# SAN FRANCISCO PLANNING DEPARTMENT

## Addendum to Environmental Impact Report

*Addendum Date:* June 7, 2011  
*Case No.:* 2006.0422E  
*Project Title:* Executive Park Amended Subarea Plan and the Yerby Company and Universal Paragon Corporation Development Projects  
*EIR Certification:* May 5, 2011  
*Project Sponsor:* George Yerby, The Yerby Company  
Jonathan Scharfman, Universal Paragon Corporation  
*Lead Agency:* San Francisco Planning Department  
*Staff Contact:* Joy Navarrete - (415) 575-9040  
Joy.Navarrete@sfgov.org

**EXHIBIT A: REVISED SITE PLAN**

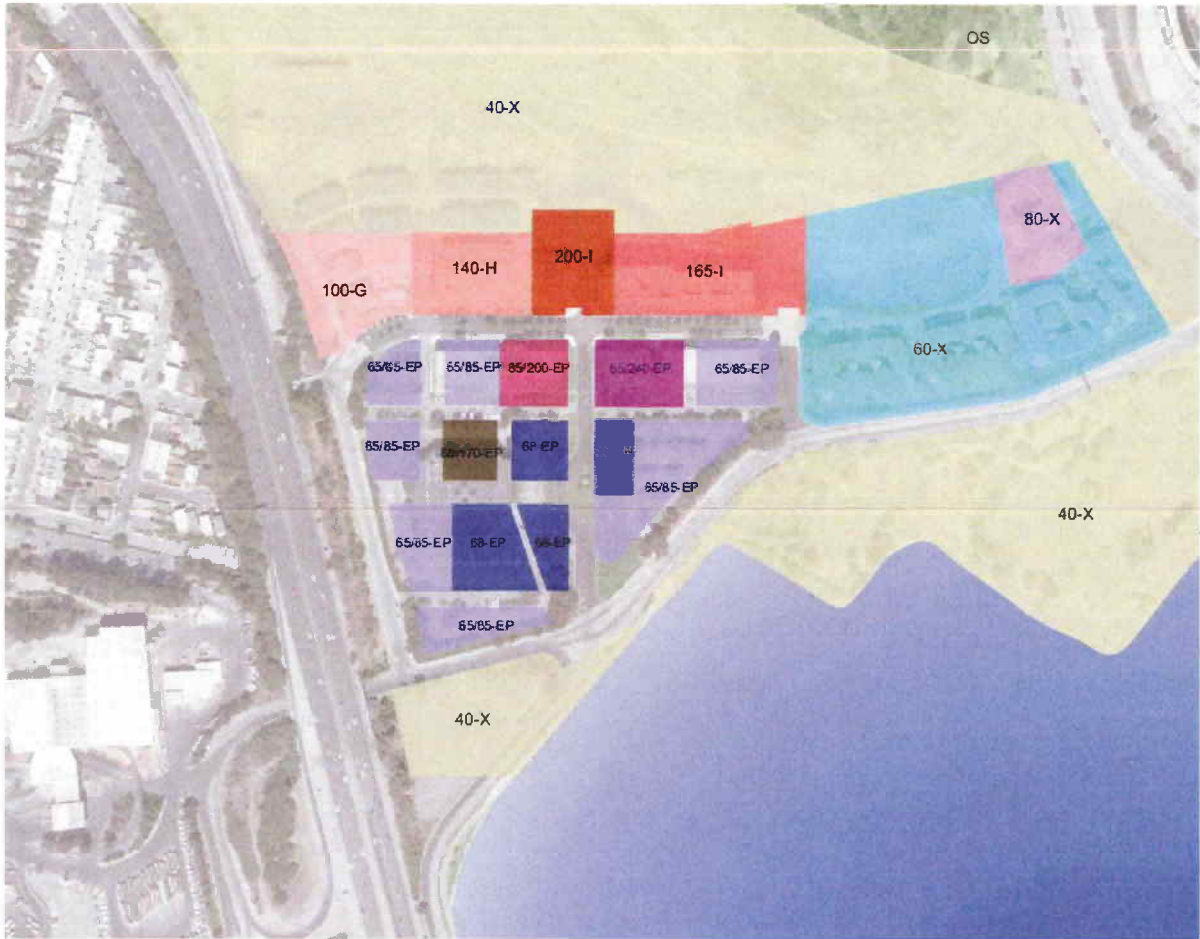
Subsequent to the certification of the final EIR, changes to the height and bulk districts for Blocks A and B have been contemplated. The contemplated revisions to the proposed project (proposed project as revised) would essentially trade the respective building heights and volumes, as originally proposed for Block A, with that of Block B, to relocate the 16-story tower height from Block A to Block B. (See Exhibit A: Revised Site Plan.) Under the proposed project as revised, Block A, instead of Block B, would receive a 65/85-EP height and bulk designation. Block B, instead of Block A, would receive a 65/170-EP height and bulk designation to allow for a 16-story tower on Block B. (See Exhibit B: Revised Height and Bulk Map.)

A 65- to 85-foot-tall, 6- to 8-story building would be constructed on Block A. The building on Block B would be similar to the footprint of the tower building previously proposed for Block A under the EIR project. The footprint of the 16-story tower building on Block B would be similar to the footprint of the tower building previously proposed for Block A under the EIR project. The tower façade would front on A Alley and E Street, with a 65-foot (6-story) podium fronting on B and D Streets. Along the A Alley frontage, the western-most part of Building B as revised, would include a 6-story base structure.

**EXHIBIT C:  
EIR PROJECT AND PROJECT AS REVISED, HIGHWAY 101 NORTHBOUND**

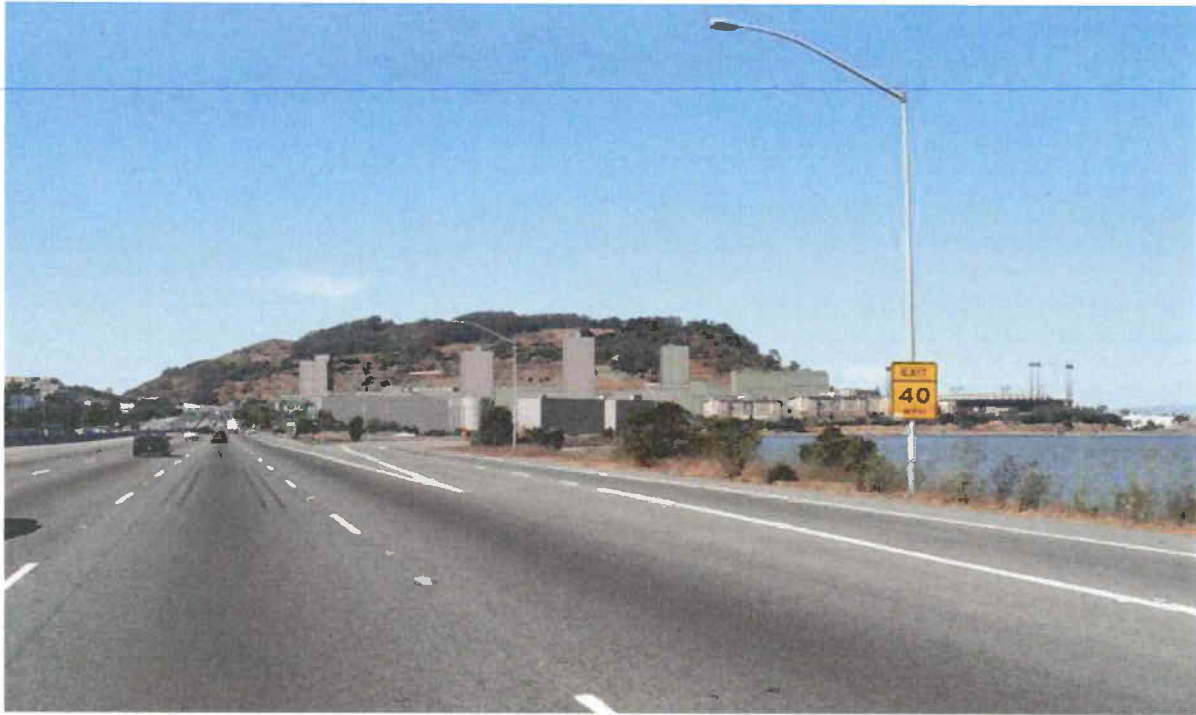
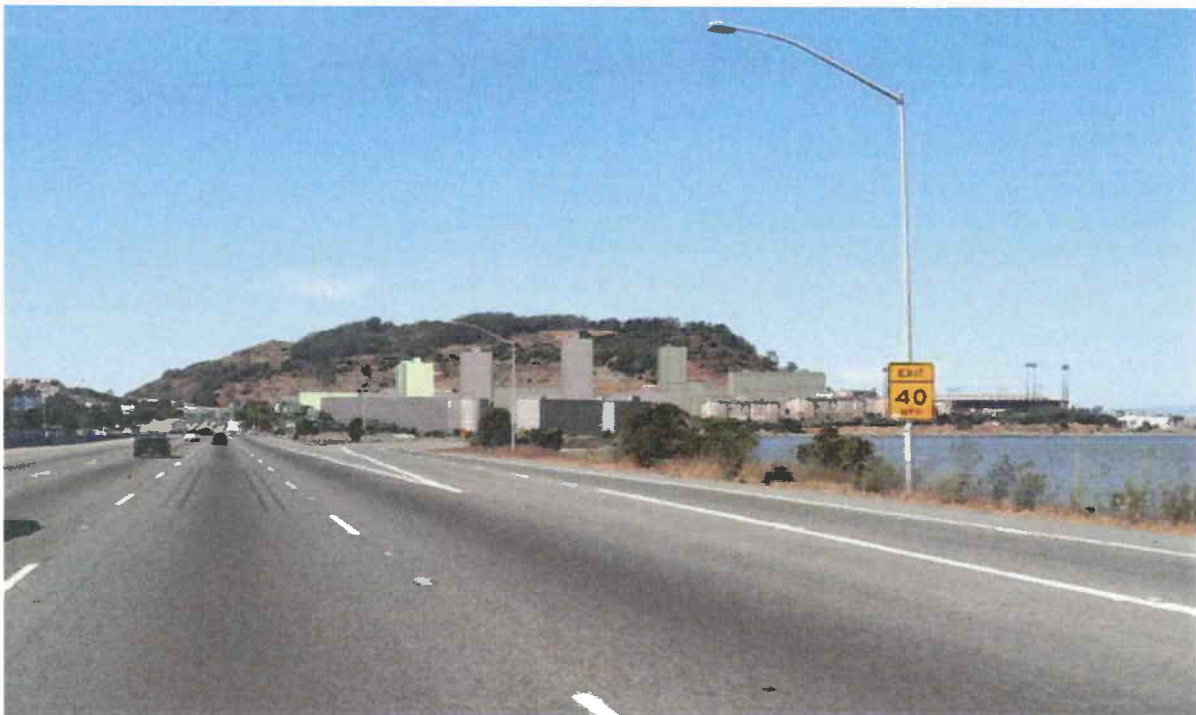
The proposed project as revised does not call for any change to the analysis and conclusions of the EIR with respect to the topic of Aesthetics (scenic resources, scenic vistas, and visual quality). (See Figure V.B-2 on EIR p. V.B.6, Figure V.B-3 on EIR p. V.B.8, Figure V.B-4 on EIR p. V.B.9, Figure V.B-5 on EIR p. V.B.11, and Figure V.B-6 on EIR p. V.B.12.) The shift of tower volume eastward would not obstruct any scenic view of the Bayview Hill scenic resource. Rather, when viewed from Highway 101 northbound, the revised configuration of heights would taper the height of development downward to the west allowing the proposed and approved tower volumes within the Subarea Plan Area to better echo the mounded shape of Bayview Hill rising in the background. (See Exhibit C: Visual Simulations - EIR Project and Project as Revised, Highway 101 Northbound.) Further, the revised configuration of heights would better preserve views of San Francisco Bay for motorists traveling southbound on Highway 101 as they approach the Subarea Plan Area from the north and for persons viewing the Bay from the raised northern end of the Little Hollywood neighborhood. (See Exhibit D: Visual Simulations – EIR Project and Project as Revised, Highway 101 Southbound. See also Figure V.B-5 on EIR p. V.B.11.)

**Potential Tower Relocation - Project Changes and Discussion**

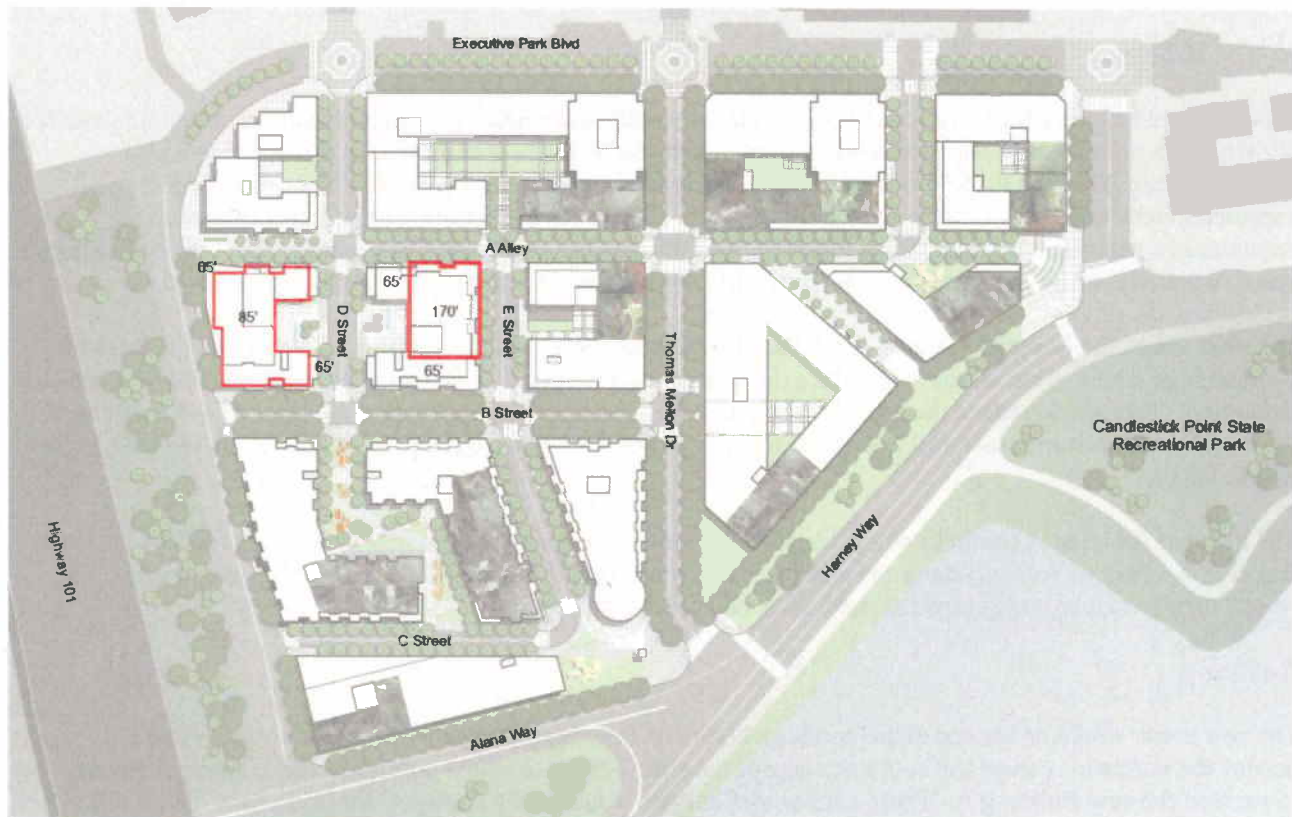
The project considered in the EIR proposes Building A as having a 16-story tower, with a 6-story base, and Building B, to the east, as an 8-story building. The contemplated tower relocation would result in Building A becoming a 6- and 8-story structure and Building B becoming a 16-story tower on a 6-story base. The footprint of the 16-story tower on Building B would be similar to the footprint of the tower of EIR project Building A. In effect, the relative building masses and towers of Buildings A and B would be exchanged. The Building B tower façade would front on A Alley and E Street, with a 65-foot (6-story) podium fronting on B and D Streets. Along the A Alley frontage, the western-most part of Building B would include a 6-story base structure. A map that shows the layout of the contemplated new configuration of Buildings A and B analyzed in this letter is presented below.
